# Responses to Comments on Draft Initial Study

September 2014

Subject: 1440 Center  
SCH#: 2014072051

Figure #1; SVWD & SLVWD Groundwater Levels - Production

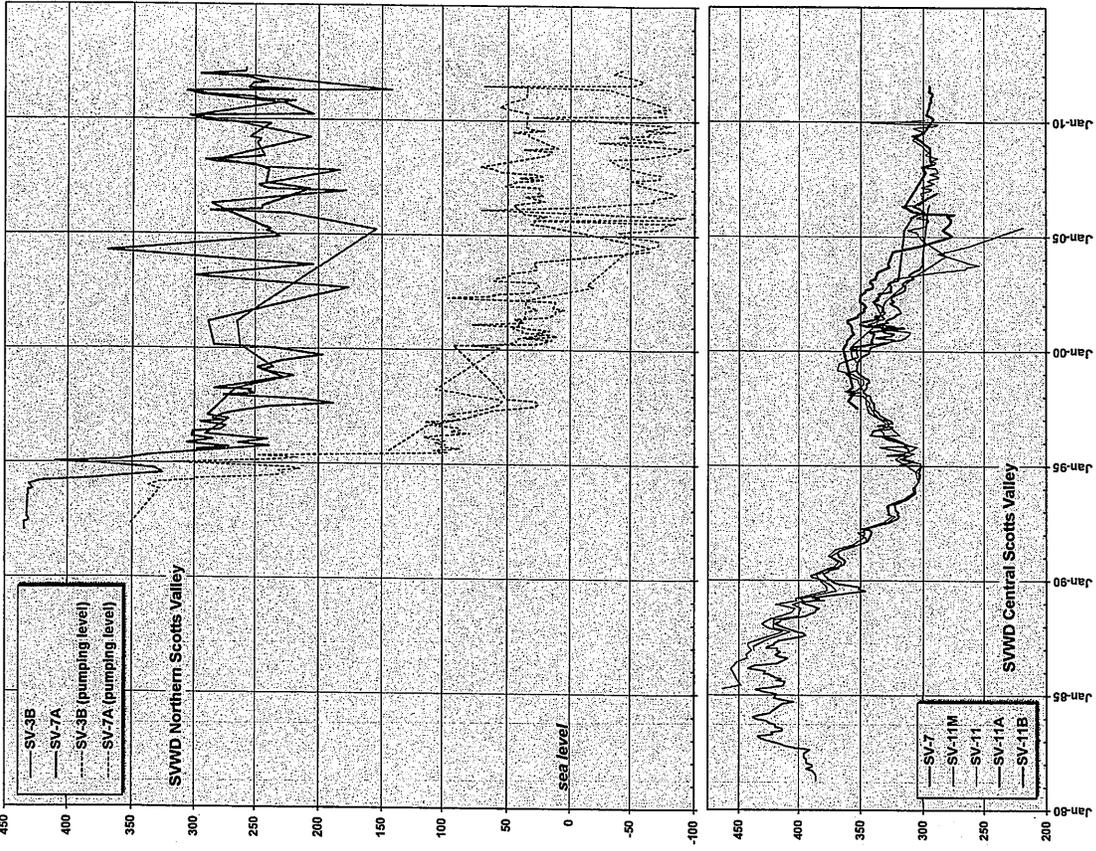
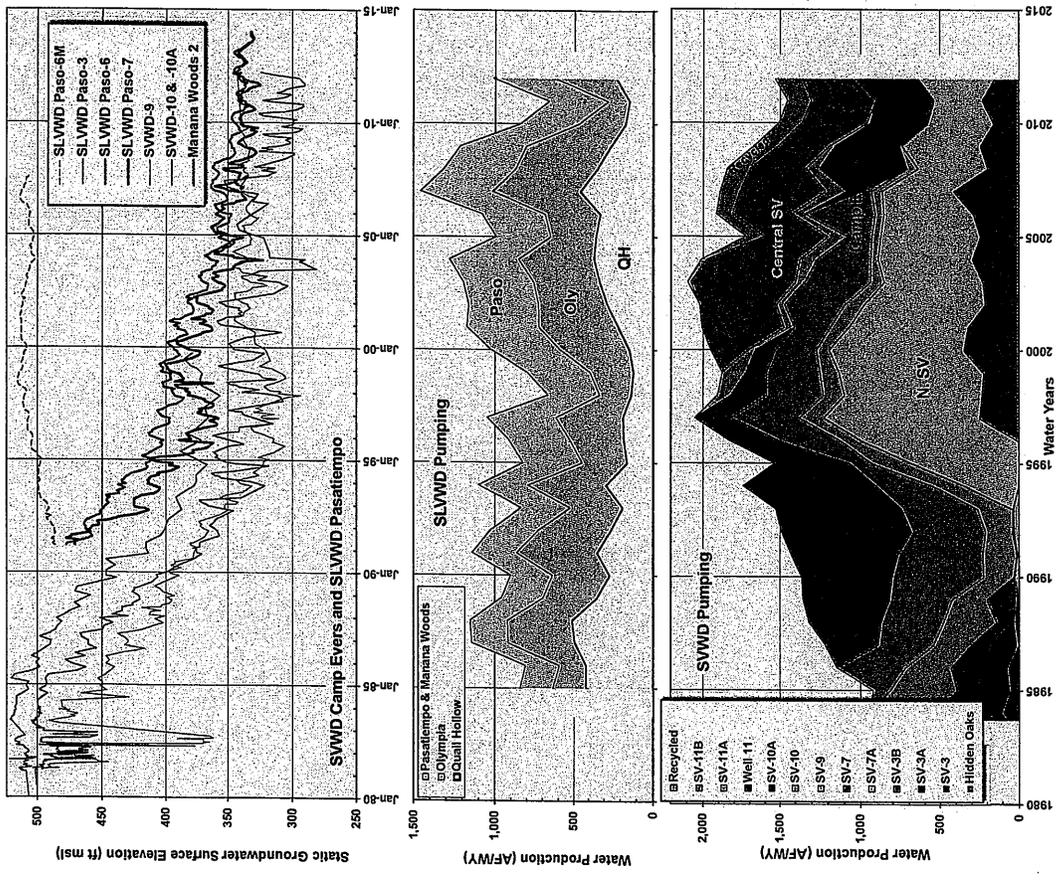
**Comment #6:** The proposed project's water use must be considered as a cumulative impact in the context of existing groundwater production in the Scotts Valley area. As shown in the attached figure, static groundwater levels in the Santa Margarita and Lompico sandstone aquifers have declined up to 300 feet since 1980. Current conditions appear to be unsustainable and/or having significant long-term impact on regional stream baseflows. Although water use declined during the recession, and the use of recycled water has increased, groundwater levels remain significantly drawn down, with some pumping levels below sea level. Furthermore, although the proposed project replaces a roughly similar use at the same site that ended in 2011, each new or renewed service should be evaluated in the context of a sustainable groundwater management plan. Additional analysis is needed to define the region's sustainable groundwater yield and acceptable impact to the local hydrology.

A comment was received clarifying the Scotts Valley Water District daily potable water demand. Total groundwater pumping by the Scotts Valley Water District in 2010 was 1,358 acre-feet per year (AFY), which is the lowest it has been since 1990. Although there has been an overall decrease in groundwater production, the SVWD has implemented a number of groundwater management programs, such as the Water

Conservation Program and the Recycled Water Program, to improve water supply security, reliability, and off-set future demand. As such, the District's groundwater production is projected to stay relatively stable and not exceed 1,352 AFY through the year 2035.

According to the Scotts Valley Water District's 2010 Urban Water Management Plan (2010 UWMP), the sustainable yield for the entire Santa Margarita Basin is estimated at 2,600 AFY. This volume represents the amount of water that is available to the water purveyors under the current pumping configuration without causing any overall change in storage. The sustainable yield represents the annual amount of water that can be taken from the existing wells in a basin over a period of years without "causing adverse impacts" (i.e. depleting storage beyond the ability of the basin to be replenished naturally). Exceeding the sustainable yield for the basin may lead to perennial declines in groundwater levels which over time may result in widespread loss of well production.

The 2010 UWMP states that SVWD's projected groundwater pumping is significantly below the estimated sustainable yield of 2,600 AFY and is expected to decline over time as recycled water is more fully utilized. Therefore, the potential increased pumping by other pumpers in the Scotts Valley groundwater subarea will likely be within the overall sustainable yield of the basin. The 2010 UWMP added that SVWD's groundwater pumping is anticipated to decline from 1,484 AFY in 2015 to 1,352 AFY in 2035 as more recycled water becomes available for non-potable irrigation from the district's Recycled Water Program and water demand reduces as a result of the district's Water Conservation Program. The 2010 UWMP concludes that given the pumping projections being below the estimated of sustainable yield, water supply reliability issues are not anticipated to occur in the SVWD service area.
